Access Compliance Report

Public Rights-of-Way

(Curb Ramps)

Intersection ID: 50494	Main Street: BLAIREBETH_ST	Cross Street: HAWFIELD_WAY_DR	Location: SE
ADA ID: 2CF05B67AA15	Ramp Type: PerpDiag	Initial Pass/Fail: Fail	Overall Compliance: No
Severity Score: 12.5			
Codes/Mitigation Info/Possible Solution		Field Measurements/Component Compliance

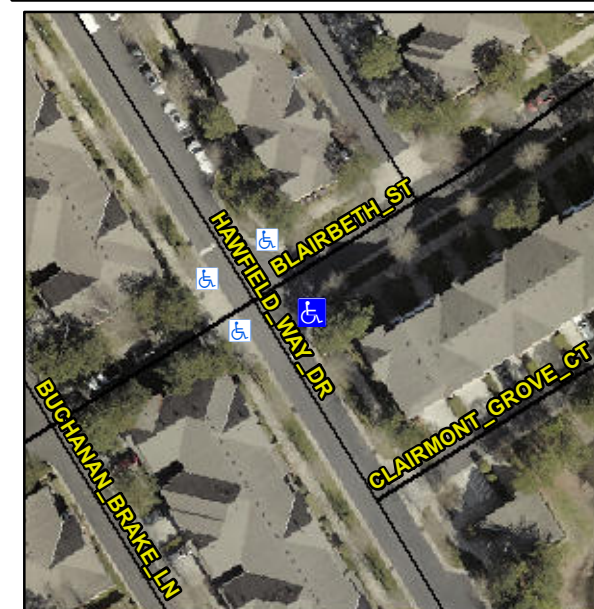
Remove & Replace Curb Ramp With Two New Directional Ramps or Equivalent.

R304.5.3
